# dsPIC33EPXXX(GP/MC/MU)806/810/814 and PIC24EPXXX(GP/GU)810/814

## dsPIC33EPXXX(GP/MC/MU)806/810/814 and PIC24EPXXX(GP/GU)810/814 Family Silicon Errata and Data Sheet Clarification

The dsPIC33EPXXX(GP/MC/MU)806/810/814 and PIC24EPXXX(GP/GU)810/814 family devices that you have received conform functionally to the current Device Data Sheet (DS70616G), except for the anomalies described in this document.

**FIGURE 1: SIMPLIFIED BEHAVIOR**

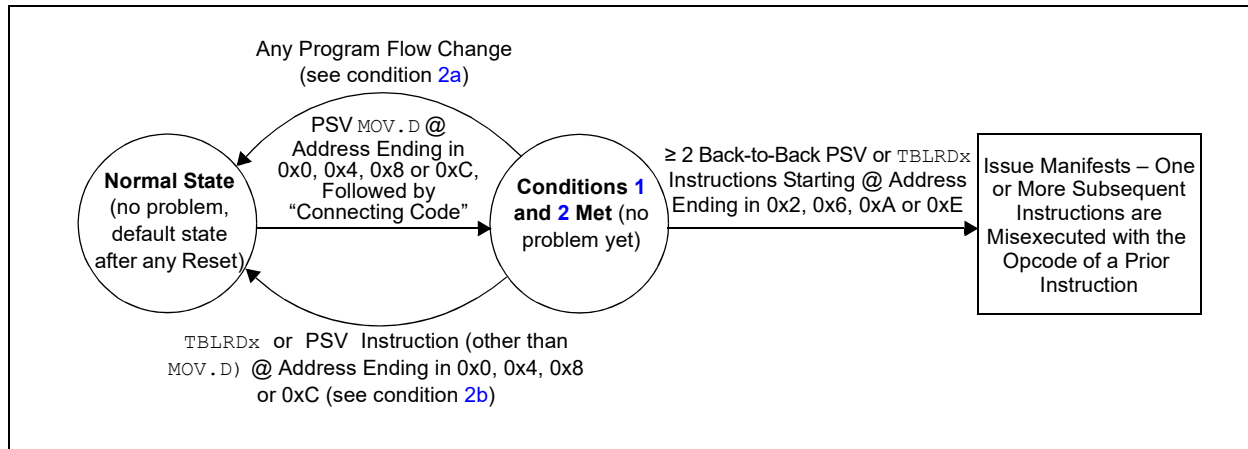
When two or more data Flash read instructions (via Program Space Visibility (PSV) read or table read) are executed back-to-back, one or more subsequent instructions can be misexecuted when all of the conditions in Table 3 occur.

1.	A PSV <code>MOV.D</code> instruction is executed, with opcode at address ending in 0x0, 0x4, 0x8 or 0xC; and
2.	Some “connecting code” is executed (following the <code>MOV.D</code> of condition 1), with the properties: <ul style="list-style-type: none"> <li>a) The connecting code does not include any program flow changes, including: taken branch instructions (including all versions of <code>BRA</code>, <code>CPBEQ</code>, <code>CPBGT</code>, <code>CPBLT</code>, <code>CPBNE</code>), <code>CALL</code>, <code>CALL.L</code>, <code>GOTO</code>, <code>GOTO.L</code>, <code>RCALL</code>, <code>RETLW</code>, <code>RETURN</code>, vectoring to an ISR, returning from an interrupt (<code>RETFIE</code>) and certain debug operations, such as <code>break</code> and <code>one-step</code>; and</li> <li>b) The connecting code does not include a <code>TBLRDx</code> or non-<code>MOV.D</code> PSV instruction, located at a Flash memory address ending in 0x0, 0x4, 0x8 or 0xC; and</li> <li>c) The connecting code is at least two instruction words in length; and</li> <li>d) The connecting code does not end with a <code>REPEAT</code> instruction, with count &gt; 0; and</li> </ul>

3.	≥ 2 back-to-back PSV or <code>TBLRDx</code> instructions are executed (following the code of condition 2), where the first of the back-to-back instructions is located at an address ending in 0x2, 0x6, 0xA or 0xE.

Figure 1 provides an example of the effective behavior.

The issue can be avoided by ensuring any one or more of the requirements are not met. For example:

1. All instances of PSV `MOV.D` can be replaced with two PSV `MOV` instructions instead. Non-PSV `MOV.D` instructions acting on RAM/SFRs do not need to be modified; or
2. If not already present, a program flow change instruction (such as `BRA $+2`) can be inserted above back-to-back data Flash read sequences; or
3. Back-to-back data Flash read instruction sequences can be broken up by inserting a non-Flash read instruction (such as a `NOB`) in between the Flash read instructions; or
4. The alignment of the code can be shifted to avoid the required opcode location addresses.

**FIGURE 16-2: HIGH-SPEED PWM MODULE REGISTER INTERCONNECTION DIAGRAM**

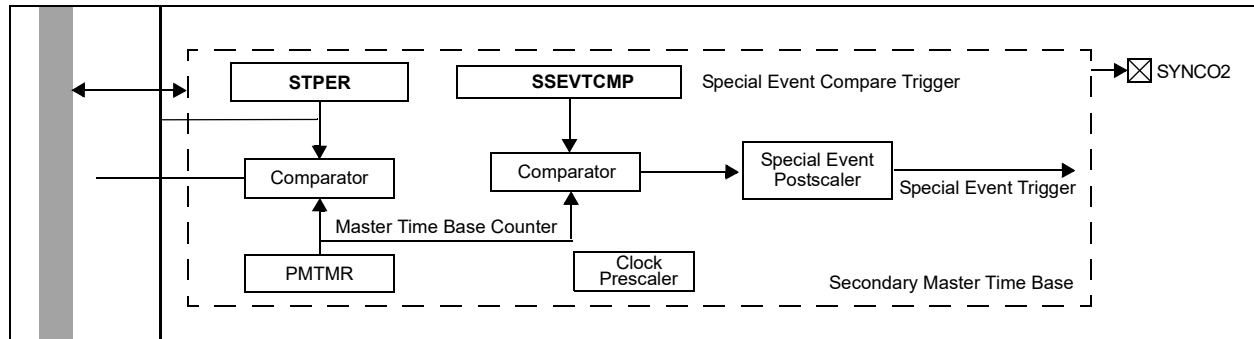
In **Figure 16-2: High-Speed PWM Module Register Interconnection Diagram**, the Secondary Master Time Base section has been updated. The updated text is shown in **bold** in [Figure 16-2](#) below.
